**H***Alouette*313  
316  
318  
319

N° 05.78

**SUBJECT :** TIME LIMITS

Monitoring the Blade Spacing System Cable-to-MRH Attachments.

FIGURE 1

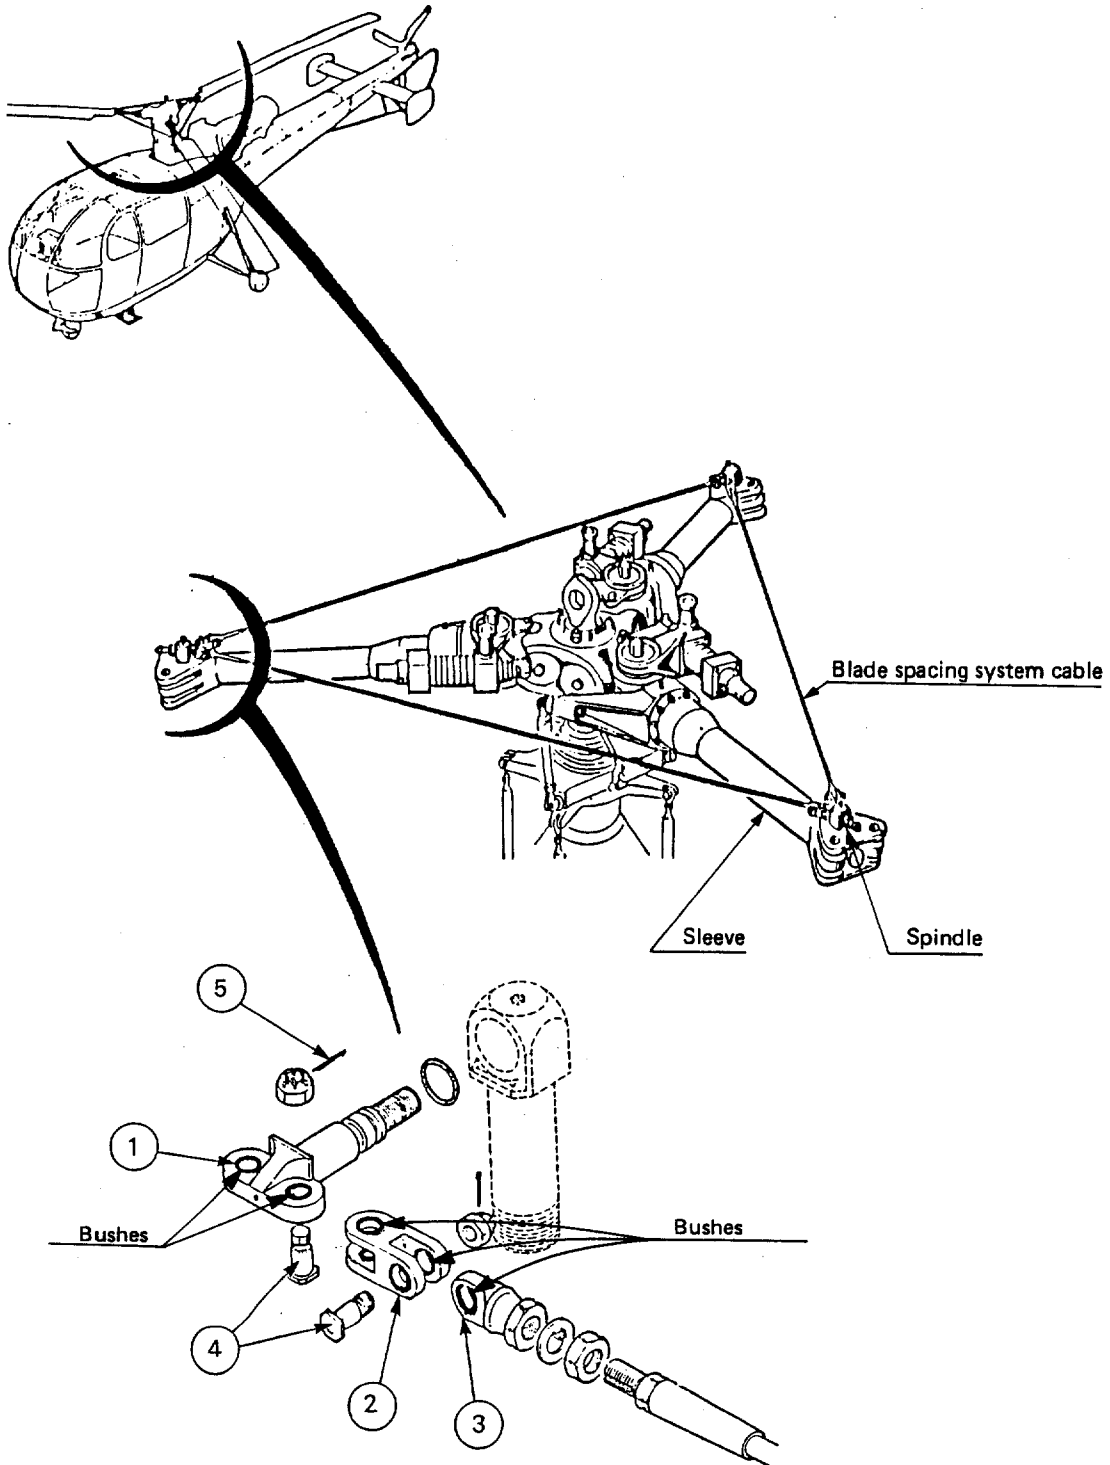
(2) Checking (Refer to Figure 1)

- Visually check that spindle bushes item 1, shackle bushes item 2 and cable end-fitting bushes item 3 are not broken.

- If no bushes are broken :  
Return the aircraft to flight configuration.
- If one or more bushes are broken :  
Replace the incriminated spindle, shackle or cable with new parts.

*After fitting bolts item 4 as per MET Work Card No. 57.00.302, page 2, check that they rotate freely. If they stick, discard and replace the incriminated bolts with new bolts.*

- In all cases, discard and replace cotter pins item 5.
